Access Compliance Report

Public Rights-of-Way

(Curb Ramps)

Intersection ID: 52266	Main Street: N_TRYON_ST	Cross Street: BROOKSIDE_LN	Location: NW
ADA ID: 8ADE94805232	Ramp Type: Perp	Initial Pass/Fail: Fail	Overall Compliance: No
Codes/Mitigation Info/Possible Solution			Severity Score: 10
			Field Measurements/Component Compliance

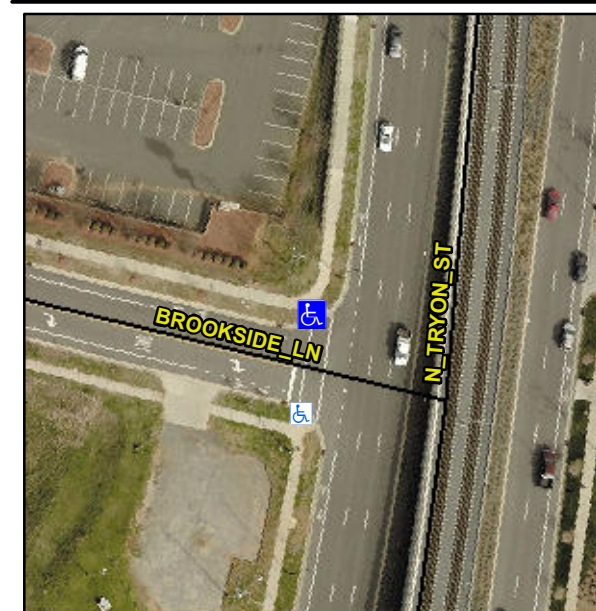
Not Found, R304.5.1, R304.5.3

Compliance	Description	Data	Compliance	Description	Data
N/A	Ramp Length (in)	96.0	Yes	Ramp Slope (%)	7.3
No	Ramp Width (in)	47.5	No	Ramp XSlope (%)	2.1
N/A	Flare Type LT	N/A	N/A	Flare Type RT	N/A
N/A	Flare Slope LT (%)	N/A	N/A	Flare Slope RT (%)	N/A
N/A	Flare Traversable LT?	N/A	N/A	Flare Traversable RT?	N/A
N/A	Landing Length (in)	N/A	N/A	DWS Provided?	N/A
N/A	Landing Width (in)	N/A	N/A	DWS Contrast?	N/A
N/A	Landing Slope (%)	N/A	N/A	DWS Length (in)	N/A
N/A	Landing X Slope (%)	N/A	N/A	DWS Full Width?	N/A
N/A	Landing Curb? (Y/N)	N/A	N/A	DWS Offset (in)	N/A
N/A	Shared Landing?	N/A			
N/A	Gutter Ponding?	N/A	N/A	Gutter Slope (%)	N/A
N/A	Gutter Lip Ht (in)	N/A	N/A	Gutter X Slope (%)	N/A
N/A	Painted X Walk1?	Yes	N/A	Painted X Walk2?	N/A
	X Walk 1 Direction	To S		X Walk 2 Direction	N/A
N/A	X Walk 1 Width (in)	110.0	N/A	X Walk 2 Width (in)	N/A
	X Walk 1 Slope (%)	2.6		X Walk 2 Slope (%)	N/A
	X Walk 1 X Slope (%)	3.5		X Walk 2 X Slope (%)	N/A

Remove & Replace Entire Ramp.
